Safety Defect and Noncompliance Report Guide for Vehicles
PART 573 Defect and Noncompliance Responsibility and Reports¹

On March 4, 20 10 Triple E RV [MFR] decided that (a defect which relates to motor vehicle safety)(a noncompliance with Federal Motor Vehicle Safety Standard No. 571.207) exists in the motor vehicles listed below, and is furnishing notification to the National Highway Traffic Safety Administration in accordance with 49 CFR Part 573 **Defect and Noncompliance Responsibility and Reports**.

Triple E RV

3417-EASY BED LOCK Uph. Procedure

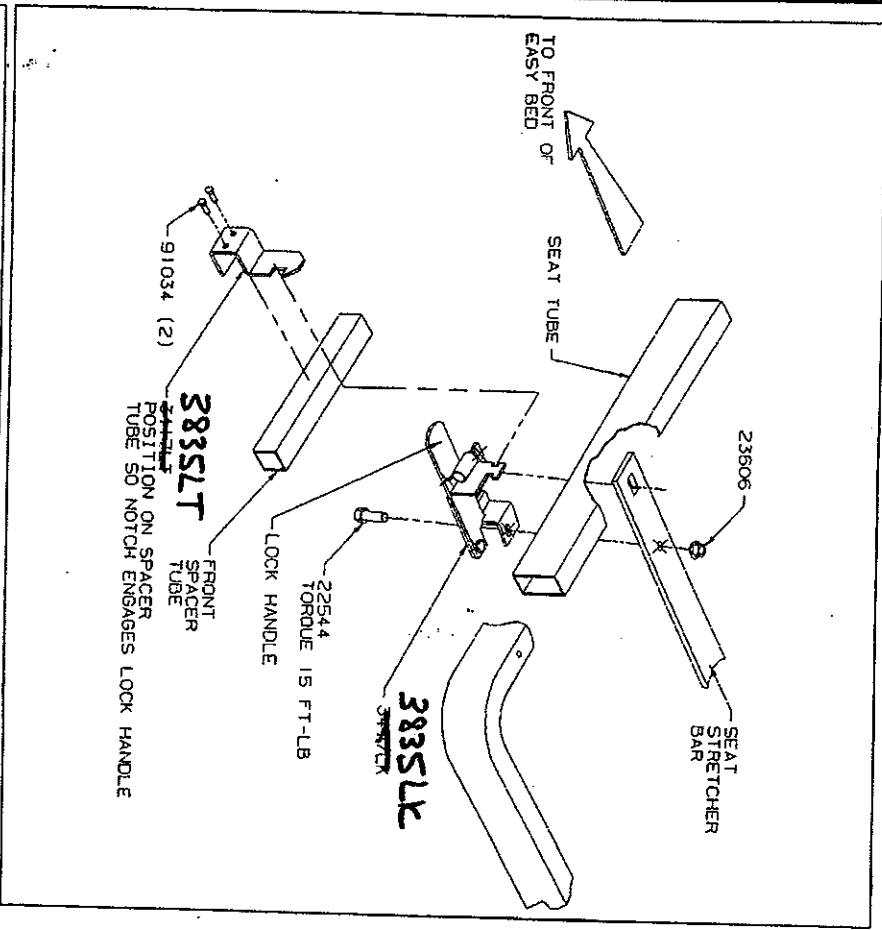
The easy-bed sofa, installed in the motorhome, was manufactured without a roll-over safety locking latch.

The easy bed sofa presently does not have a roll-over safety
locking latch to keep sofa bed locked for travel. Dealer
will install the roll-over safety locking latch to prevent the
sofa from opening. As per attached instructions.

OPTION 38 "": NO LOCK ASSEMBLY
 OPTION 38 "I": LOCK ASSEMBLY

1. Insert the tab on 3417LK into the slot in the Seat Stretcher Bar. Rotate the 3417LK until the slot in 3417LK lines up with the hole in the Seat Stretcher Bar.
2. Insert a 22544-.312-18UNC-2A X .750 GRADE 5 HEX HEAD SCREW (supplied) thru the slot in 3417LK and the hole in the Seat Stretcher Bar as shown.
3. Secure with a 23606-.312-18UNC-2B HEX FLANGE NUTT (supplied) on the upper side of the Seat Stretcher Bar as shown. Torque 22544 to 15 FT-LBS.
4. With the Bed closed, position the 3417LT on the Front Spacer Tube as shown. Slide the 3417LT on the Tube until the notch engages the 3417LK Lock Handle. Move the 3417LT away from the 3417LK approximately 1/16" for clearance.
5. Secure the 3417LT to the Tube with (2) 91034-#10-16 X .750 HEX WASHER HEAD SELF-DRILLING SCREW (supplied) as shown.
6. Open and close the Bed several times to insure proper Lock Operation.
